ADDENDUM NO. 2

PROJECT NAME: **CESAR CHAVEZ PARK PERIMETER PATHWAY
IMPROVEMENT PROJECT**

SPECIFICATION NO.: **25-11702-C**

DATE: **APRIL 10th, 2025**

TOTAL SHEETS: 16
 FILE No.: SCC.22-155
 SCALE: 1" = 5'
 SHEET No. **C-3**

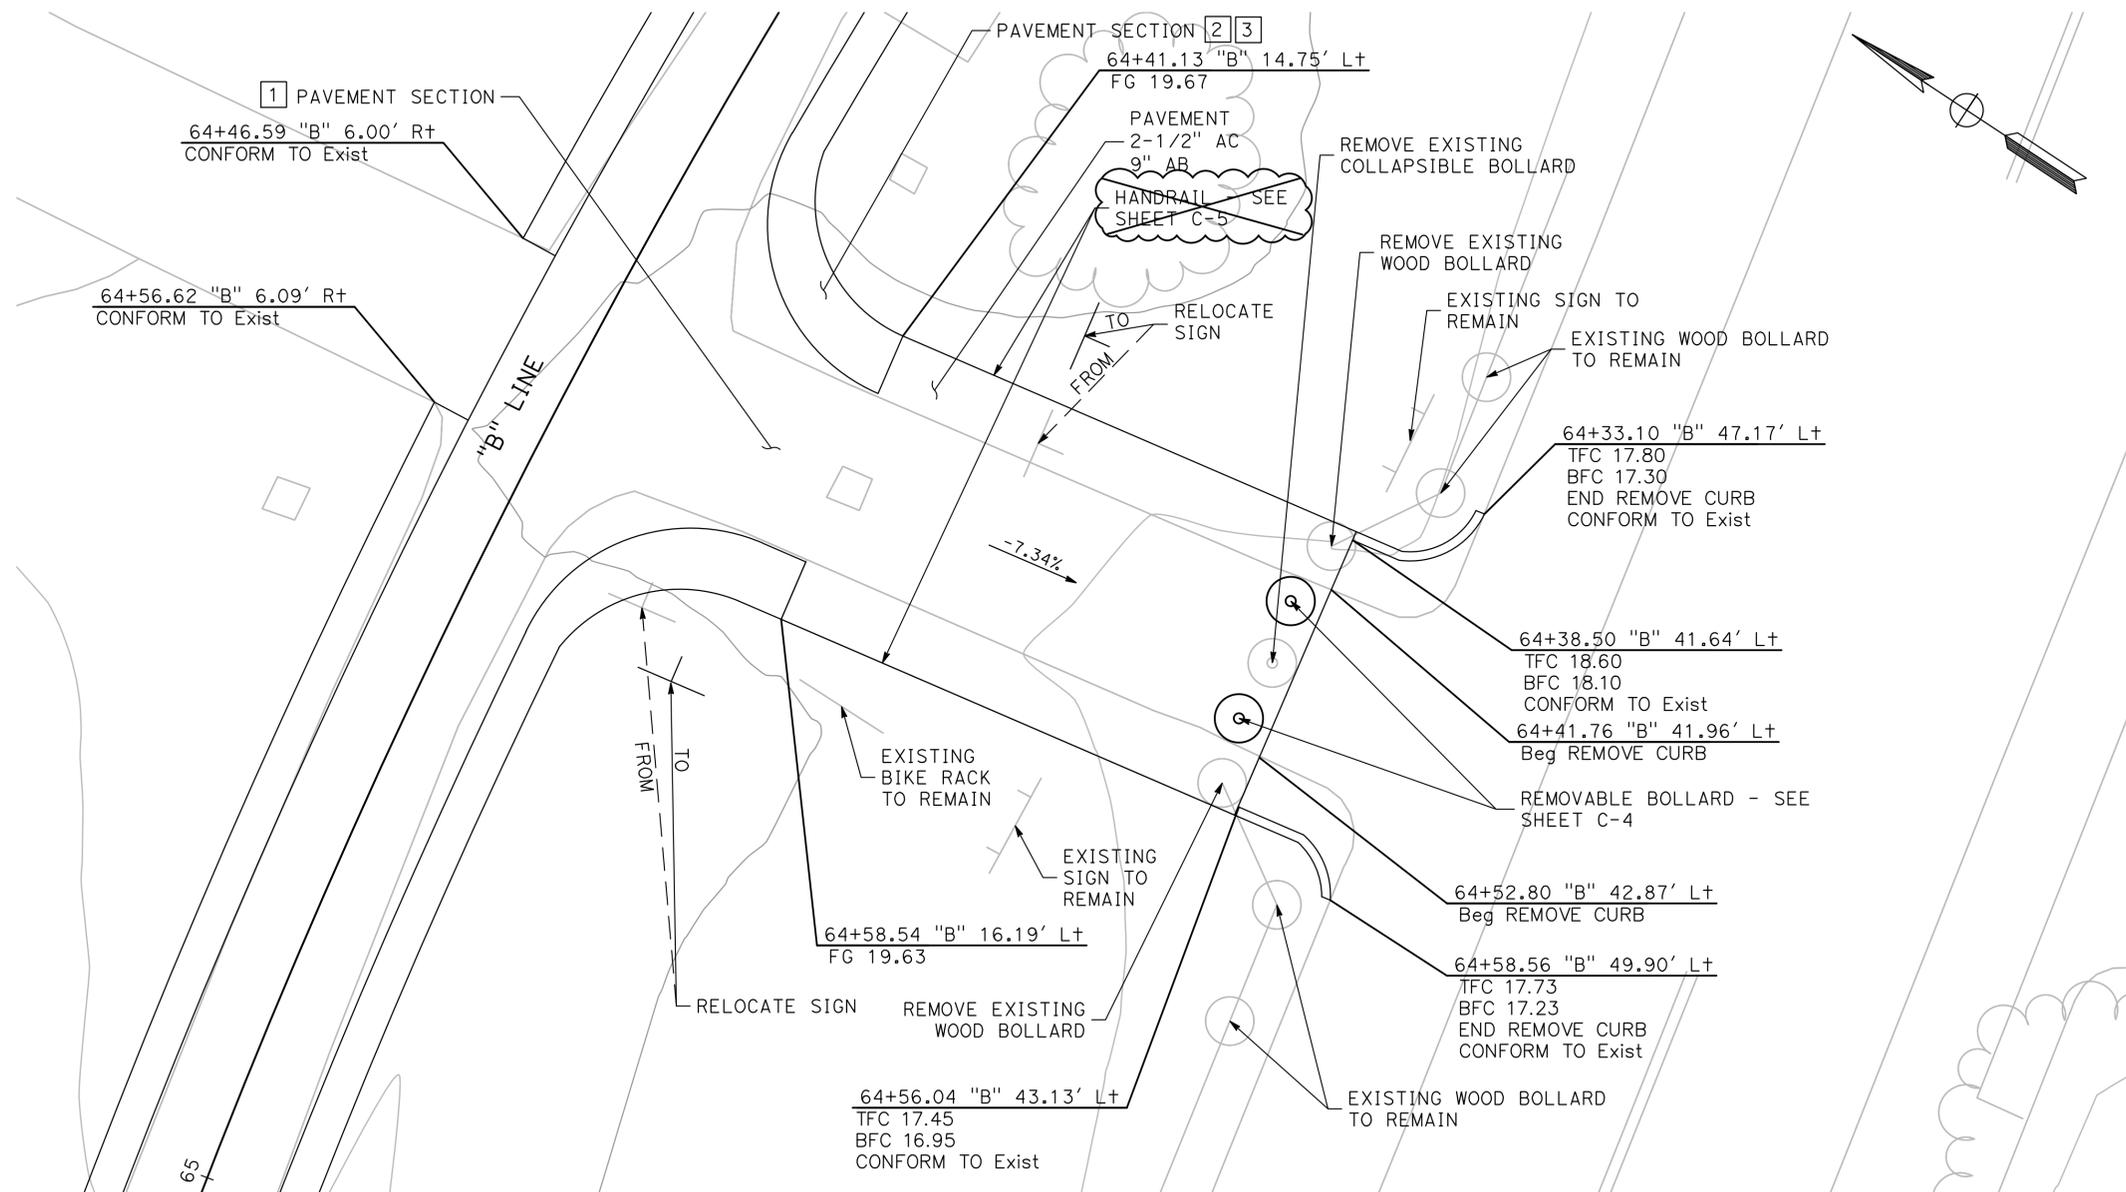
- Sheet C-3, remove handrail from plans.
 - Sheet C-4, update Collapsible Bollard Detail, add 6” Vertical Curb Detail, add dimension to Adjust Monitoring Well Detail.

8. Please provide a bid item for the removal of the curb shown on Plan Sheet C-3, or specify how this is to be measured and paid for

Response: Bid Item No. 22 - REMOVE CURB has been added. Please see attached Revised Bidder’s Proposal - Addendum 2 and attached Technical Specification, **BID ITEM NO. 22 – REMOVE CURB.**

RAMP WITH HANDRAIL - SIDE SECTION
NO SCALE

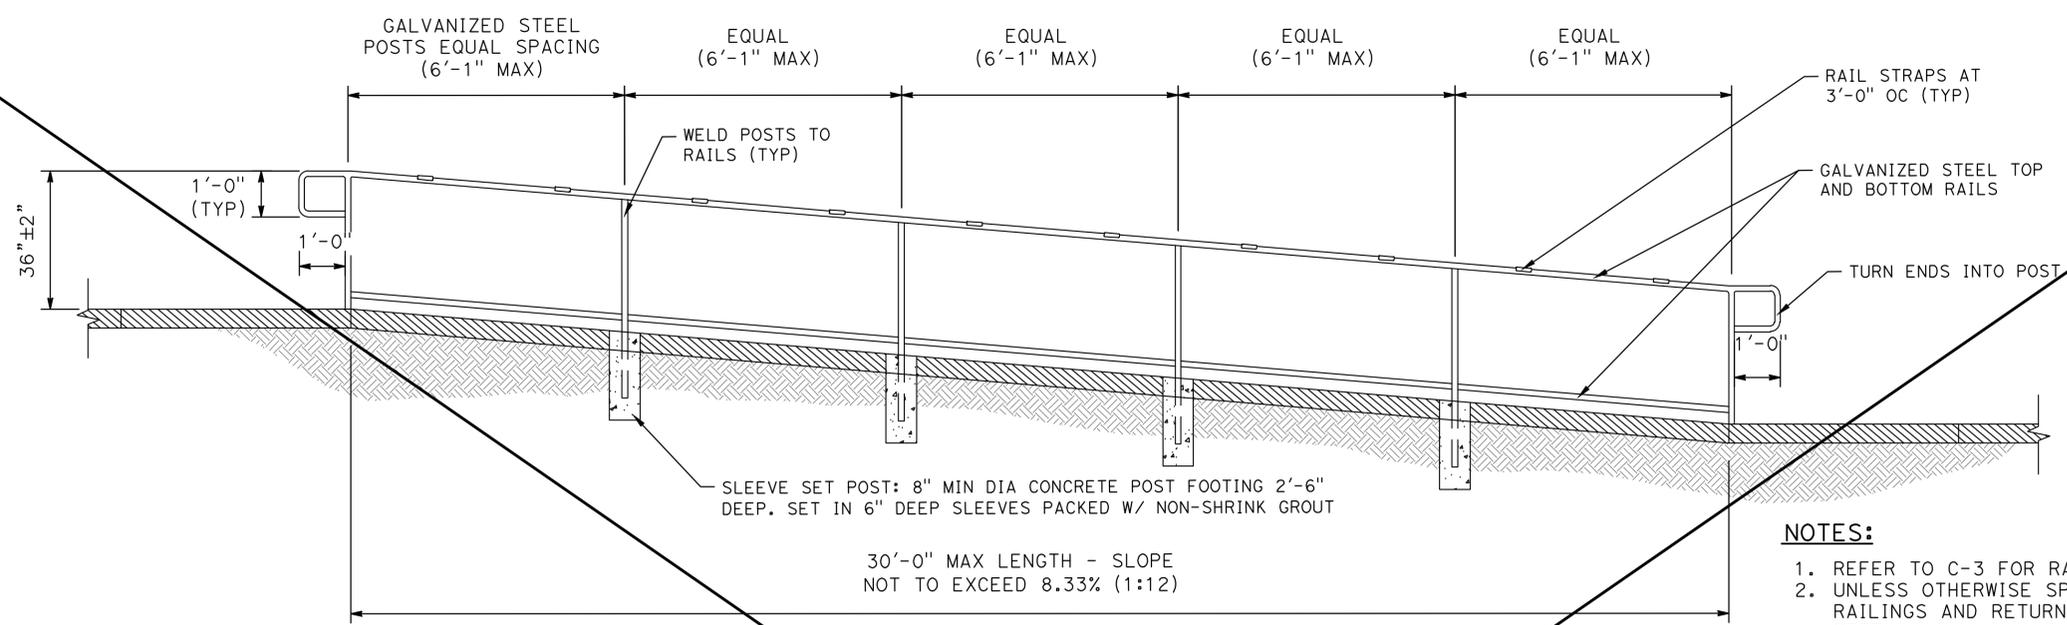
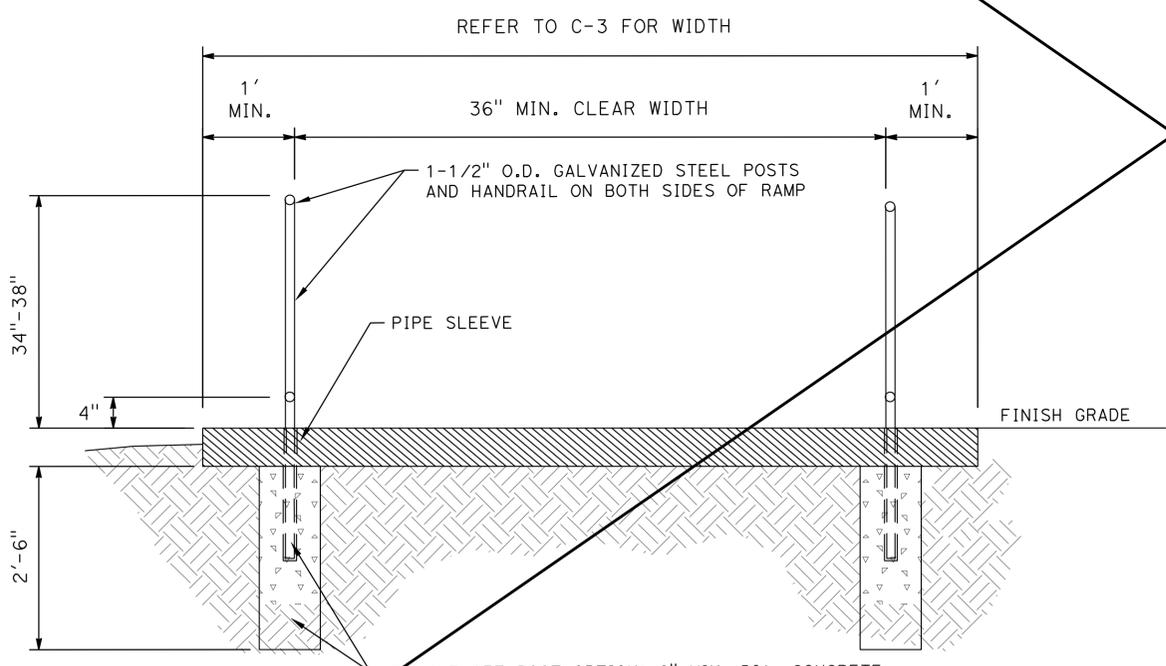
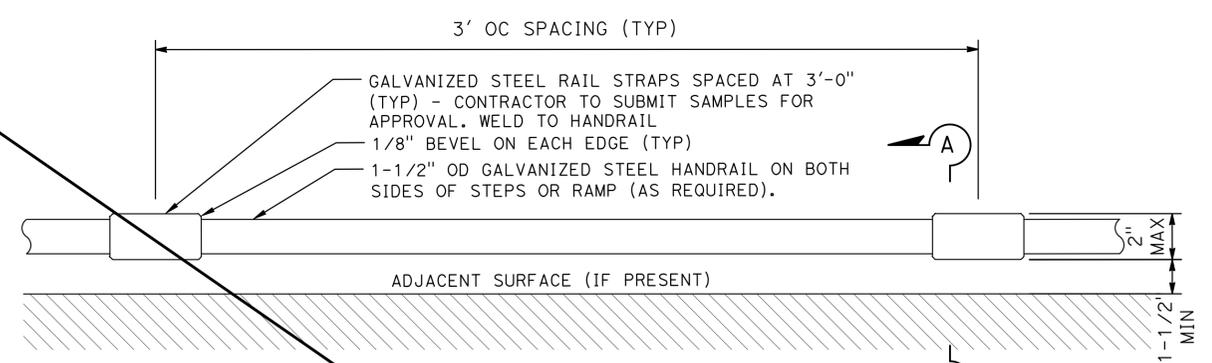
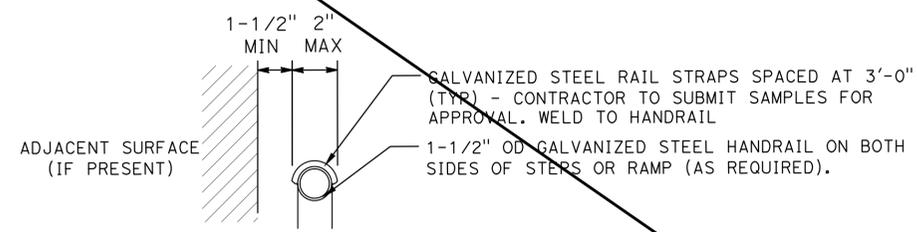
- Sheet C-5, remove handrail construction details from plans.
 - Sheet C-6, add Trash Receptacle Concrete Pad (Base Bid and Additive Bid Schedule A).

12. The plan details clearly call for a galvanized finish (typical for this type of project) while the specifications clearly call for a primer + paint coat. These two documents seem to conflict with one another. Can you please clarify the intent for this finish on the handrails for this project?

13. The plans require a galvanized (steel) skate deterrent to be installed every 36” o.c. on each rail. Would an aluminum (pre-manufactured) product be an allowable substitute for this as there are actually a number of aluminum “stake deterrents” already readily

14. The plans call for a 6" sleeve at each rail post. I assume this is to allow access to the rail post's concrete footings after the installation of the concrete flatwork in that area. That being said, this method of installation is costly and prone to logistical issues as it requires a lot of overlap between the concrete and misc. metals subcontractor's scopes. It also requires the excess sleeve material to be cut to grade after flatwork is completed which can be an issue, aesthetically. Is there any reason why we couldn't simply surface/flange mount these rail posts to the top of the completed concrete ramp? It would provide a much more cost effective and aesthetically pleasing end product.

Response: Railings have been removed from the Project, please refer to attached revised Sheet C-5.

Response: Railings have been removed from the Project, please refer to attached revised Sheet C-5.

Response: Railings have been removed from the Project, please refer to attached revised Sheet C-5.

TOTAL SHEETS: 21
FILE No.: SCC 22-155
SHEET No.: **C-6**

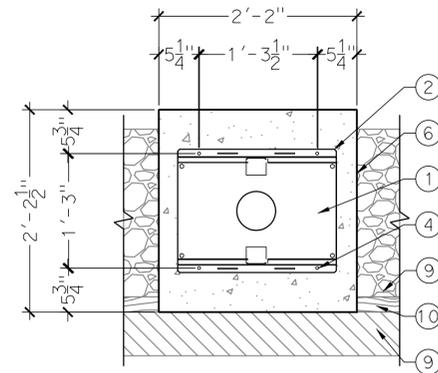
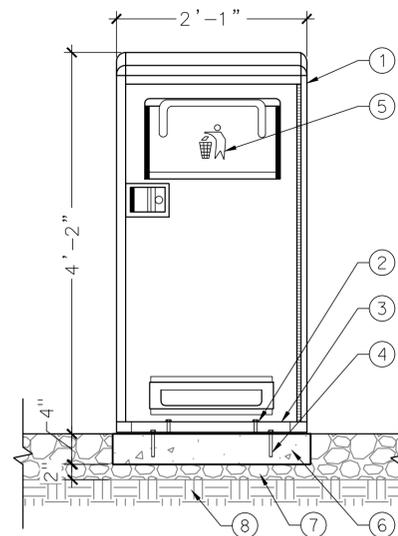
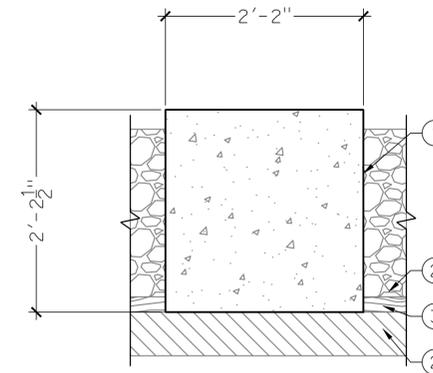
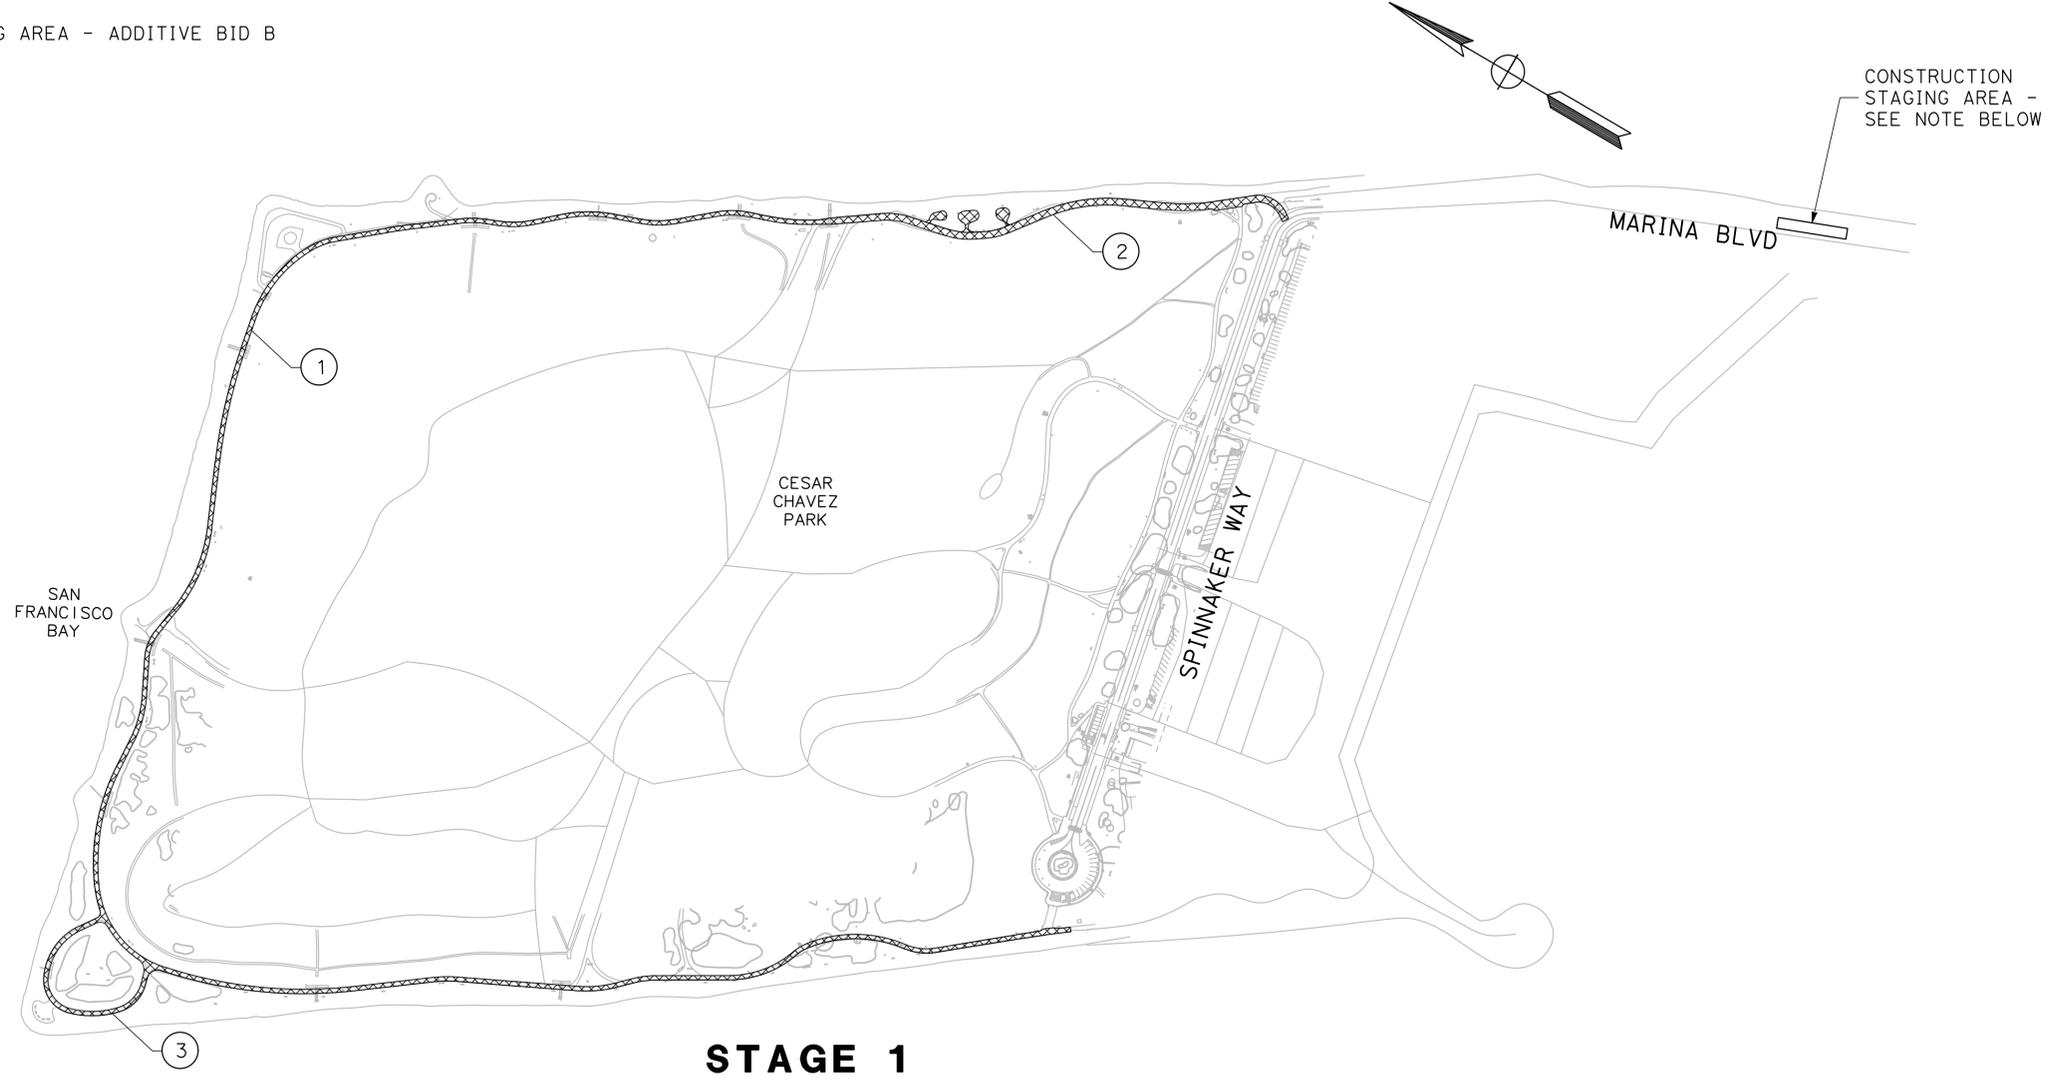
9. Please specify where Bid Item 20 – Site Concrete (Concrete Pads) in the Base Bid is located and what is to be constructed. I am unable to locate this on the plans

10. Please specify where Bid Item 7 – Site Concrete (Concrete Pads) in Additive Bid Schedule A is located and what is to be constructed. I am unable to locate this on the plans.

Response: Bid Item No. 20 – Site Concrete (Concrete Pads) refers to the concrete pads for trash receptacles, please see revised Sheet C-6, Trash Receptacle Concrete Pad Detail for dimensions. Bid Item No. 20 - Site Concrete (Concrete Pads) work is to be installed at the R03, R06 - R11, R18 - R24 locations as shown on the Plans.

Response: Additive Bid Schedule A - Bid Item No. 7 – Site Concrete (Concrete Pads) refers to the concrete pads for trash receptacles, please see revised Sheet C-6, Trash Receptacle Concrete Pad detail for dimensions. Additive Bid Schedule A – Bid Item No. 11 – Site Concrete (Concrete Pads) are to be located at R14 – R15 as shown on the plans.
